From: Pederson Ronda M (AREVA NP INC) [Ronda.Pederson@areva.com]
Sent: Friday, April 03, 2009 5:08 PM
To: Getachew Tesfaye
Cc: KOWALSKI David J (AREVA NP INC); BENNETT Kathy A (OFR) (AREVA NP INC); DELANO Karen V (AREVA NP INC)
Subject: Response to U.S. EPR Design Certification Application RAI No. 174, Supplement 2
Attachments: RAI 174 Supplement 2 Response US EPR DC.pdf

Subject: Response to U.S. EPR Design Certification Application RAI No. 174, Supplement 1

QUESTIONS for Balance of Plant Branch 1 (AP1000/EPR Projects) (SBPA)

Figure 9.2.2-1—Component Cooling Water System Trains 1 through 4
Sheet 1 of 2

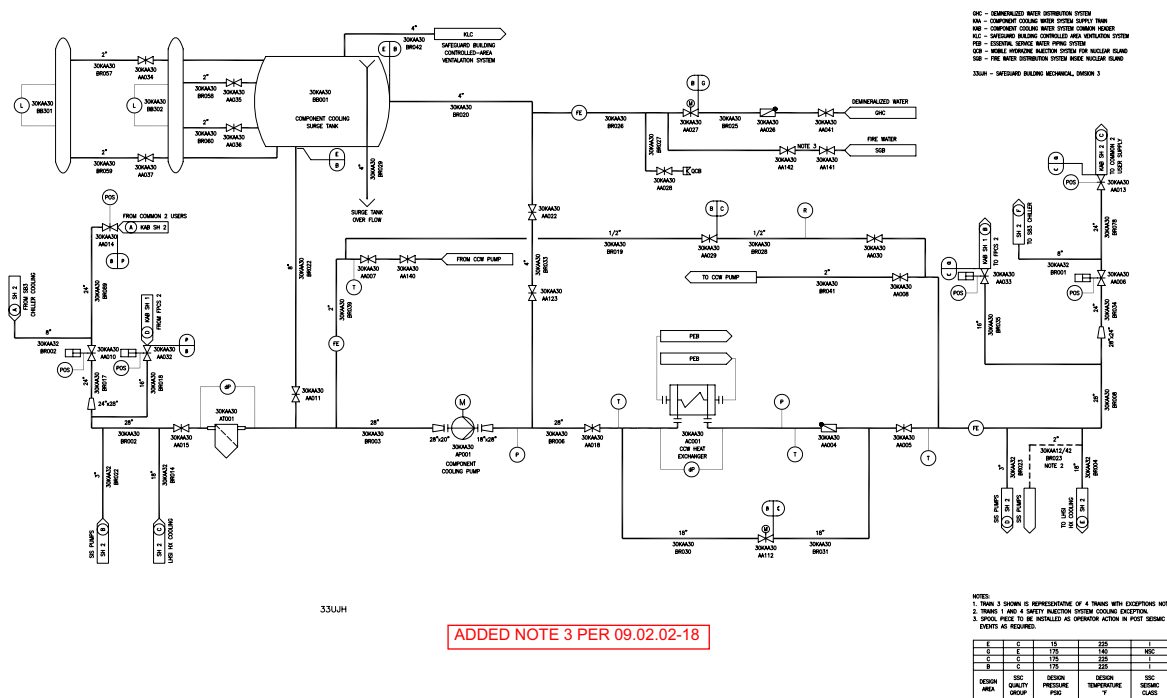
The component cooling water system (CCWS) must be capable of removing heat from systems, structures and components (SSCs) important to safety during normal operating and accident conditions over the life of the plant in accordance with General Design Criteria (GDC) 44 requirements. In order to satisfy system flow requirements, the CCWS design must assure that the minimum net positive suction head (NPSH) for the CCWS pumps will be met for all postulated conditions, including consideration of vortex formation. The staff found that the NPSH requirement for the CCWS pumps was not specified and Tier 2 Final Safety Analysis Report (FSAR) Section 9.2.2 did not describe how the CCWS design will assure that the NPSH requirement for the CCWS pumps is satisfied (including consideration of vortex formation) and how much excess margin is provided by the CCWS design for the most limiting assumptions. Consequently, the FSAR needs to be revised to address the following considerations:

- b. The bases for the MIN-MAX surge tank setpoints needs to be explained. Surge tank design details such as system internal volume, temperature extremes that are accommodated by the design, and the maximum leakage rate that is assumed including justification are some of the factors that need to be addressed. Provide in the FSAR key assumptions and conclusion from the design calculations used for sizing the component cooling water system surge tank. These calculations should be made available for staff audit.

Indications and alarms that will be available in the MCR and the Remote Shutdown Station will be identified later in the design process. U.S. EPR FSAR Tier 1, Figure 2.7.1-1—Component Cooling Water System Functional Arrangement, Sheets 1 through 4, and U.S. EPR FSAR Tier 2, Figure 9.2.2-1—Component Cooling Water System Trains 1 through 4, Sheet 1 of 2 will be revised to include manual isolation valves AA141 and AA142 as well a note explaining the spool piece insertion. U.S. EPR FSAR Tier 1, Table 2.7.1-1—Component Cooling Water System Equipment Mechanical Design will be revised to include these valves.

U.S. EPR FSAR Tier 1, Figure 2.7.1-1 and Table 2.7.1-1, and U.S. EPR FSAR Tier 2, Figure 9.2.2-1 will be revised as described in the response and indicated on the enclosed markup.

Figure 2.7.1-1—Component Cooling Water System Functional Arrangement
Sheet 18 of 24

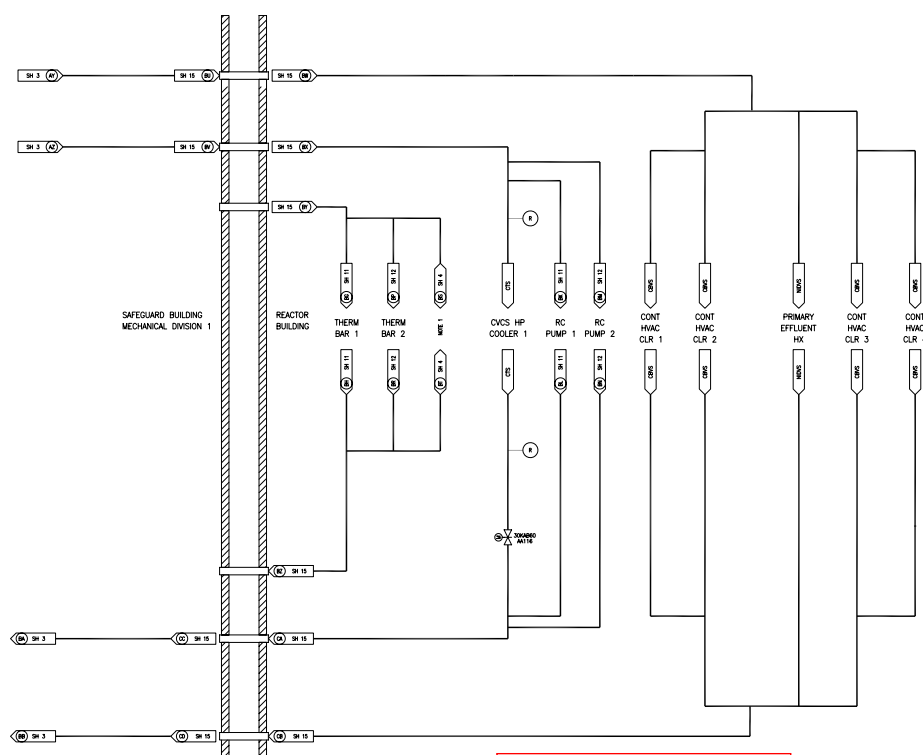
Regulatory Guide (RG) 1.21, "Measuring, Evaluation and Reporting Radioactivity in Solid Wastes and Releases of Radioactive Materials in Liquids and Gaseous Effluents from Light Water Cooled Nuclear Power Plants," indicates that monitoring should be included for anticipated operational occurrences. Standard Review Plan (SRP) 9.2.2, Areas for Review Section I.10, specifies review of the means provided for detecting leakage of radioactivity from one system to another and for precluding its release to the environment. The staff noted that FSAR Tier 2 Section 9.2.2.6 indicates that radiation monitors are provided in a recirculation line for the component cooling water system (CCWS) heat exchangers, part of the thermal barrier piping discharge, and in the return path from the high pressure (HP) chemical and volume control system (CVCS) and coolers inside containment. Furthermore, the applicant stated in FSAR Section 9.2.2.6.1 that automatic isolation is provided (i.e. both CCWS and CVCS) in case of a reactor coolant system (RCS) fluid leak into the CCWS from the HP CVCS cooler that results in a high radiation signal. The CCW heat exchanger recirculation line radiation instrument provides continuous monitoring. The staff found that the following considerations need to be addressed in the FSAR:

- a. Many current plants have provisions for automatic isolation of the CCWS surge tank vent on a high radiation signal. Describe the basis for not providing this capability to avoid inadvertent contaminating the ventilation system and in particular, how the requirements specified by 10 CFR 20.1406 are satisfied in this regard.
- b. The CCWS radiation monitors are relied upon for satisfying 10 CFR 20.1406 and GDC 64 requirements and are considered to be important system design features. Therefore, these monitors should be identified on FSAR Tier 1 Figure 2.7.1-1.
- c. The CCWS and chemical and volume control system (CVCS) valves that close automatically on a high radiation alarm associated with the CCWS return flow from the high pressure CVCS heat exchanger need to be described.

- b. U.S. EPR FSAR Tier 1, Figure 2.7.1-1—Component Cooling Water System Functional Arrangement, Sheets 1 through 4, 12 and 18 will be revised to depict these radiation monitors. U.S. EPR FSAR Tier 1, Table 2.7.1-2—Component Cooling Water System Equipment I&C and Electrical Design will be revised to include these monitors.

U.S. EPR FSAR Tier 1, Figure 2.7.1-1 and Table 2.7.1-2, and U.S. EPR FSAR Tier 2, Section 9.2.2.3.1 will be revised as described in the response and indicated on the enclosed markup.
